Department of Agriculture and Water Resources

Technical Review of Derwent Park Stormwater Harvesting and Reuse Scheme Decommissioning

January 2019

Figure 1 The Treatment and Reuse Components of the Scheme (from Section 2.4 of the Business Case)

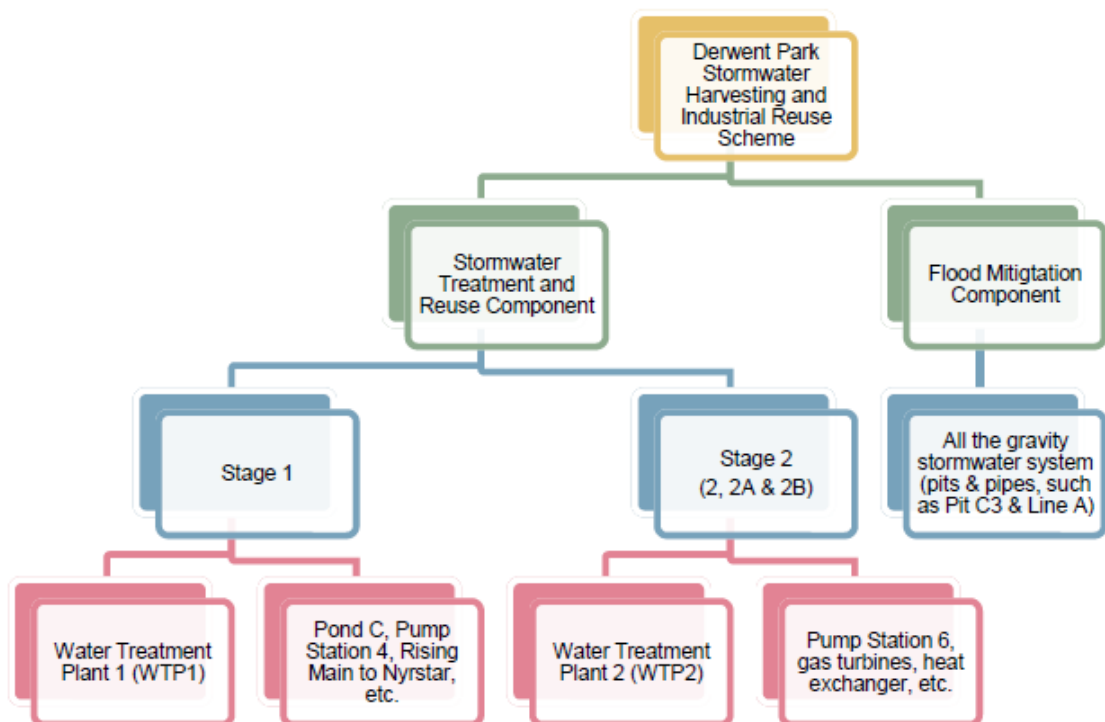
It is understood from the Business Case, and subsequent advice from Council, that Council is proposing to decommission the Treatment and Reuse Component of the Derwent Park Stormwater Harvesting and Reuse Scheme. . The Treatment and Reuse Components of the scheme are illustrated in Figure 1 below (from Section 2.4 of the Business Case).

Given the lack of primary stormwater treatment (such as GPTs, sediment ponds or swales) or secondary stormwater treatment (such as wetlands or bioretention system), the remaining elements provide limited, if any, reduction in pollutant loads. It is for this reason that the Council's Business Case proposes the installation of a GPT in Pit C3 to remove gross pollutants from the stormwater, noting that this has not yet occurred.

We are not sure whether the proposed Ecosol trash rack shown in the Business Case is the most appropriate GPT for the application, with other products available that are more suited to retrofitting in stormwater pits. Notwithstanding this, the approximate capital cost of retrofitting a GPT to Pit C3 is likely to be of the order of \$100,000 to \$200,000, noting that the GPT will have substantial ongoing operation and maintenance costs that will need to be funded by Council.

Without the proposed GPT, it is not clear how there could be any reduction in pollutant loads entering the Derwent River. . As such, it is critical that Council be required to retrofit a GPT in Pit C3 (as a minimum) to capture gross pollutants during higher frequency flood events. . It is noted that the efficiency of the GPT in removing gross pollutants relies on a regular maintenance program of cleaning.
